# URBAN DESIGN REPORT

SITE PLAN CONTROL

SUBJECT SITE: 116-118 CARRUTHERS AVENUE

REPORT DATE: NOVEMBER 15, 2024

Figure 4: Front, Side (South and North) and Rear Elevations of proposed development (Source: Redline Architecture)

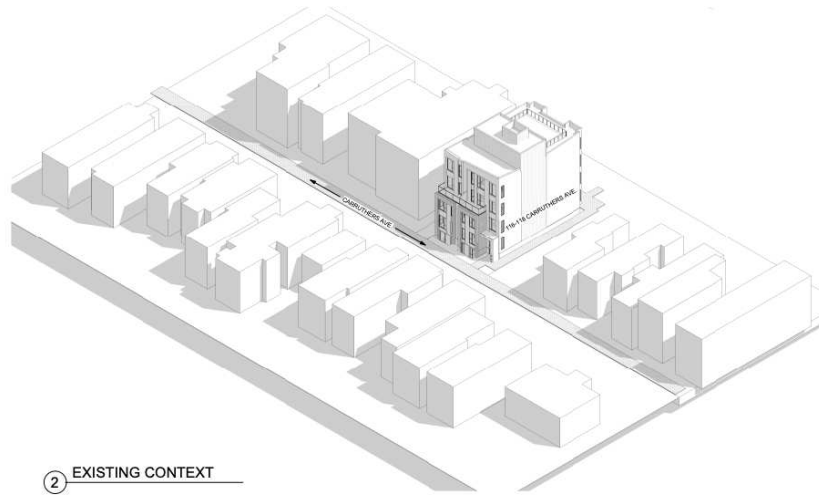
<b>Recommendations</b>	
<p>We recommend the materiality of the side elevations be a cementitious product which is more compatible with a residential neighbourhood (as opposed to a very large wall of corrugated metal which gives an industrial look and will be very visible in the neighbourhood).</p>	<p>No corrugated metal is used. Metal panel is proposed.</p>
<p>We recommend taking advantage of the additional side yard separation to the south to increase glazing and make the units more livable.</p>	<p>Windows are used as many as possible on the south side of the property. In the future we will adjust window size and locations depending on unprotected opening calculations.</p>

Figure 5: 3D renderings of proposed development showing surrounding existing planned context (Source: Redline Architecture)

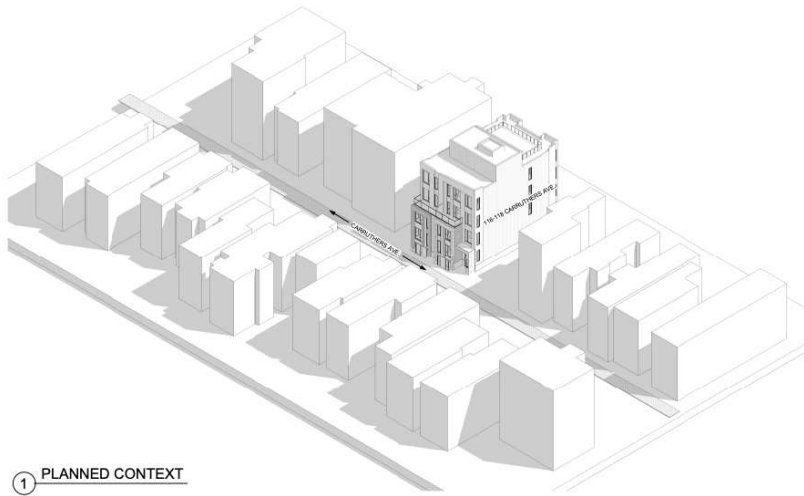
We recommend providing the built form planned context in the 3D modelling illustrations to help analyze the scale of the proposal in its context. This can be ghosted blocks on the neighbouring properties.

Please see the existing and planned context 3D models in Section 4.0 Design Research of this report.
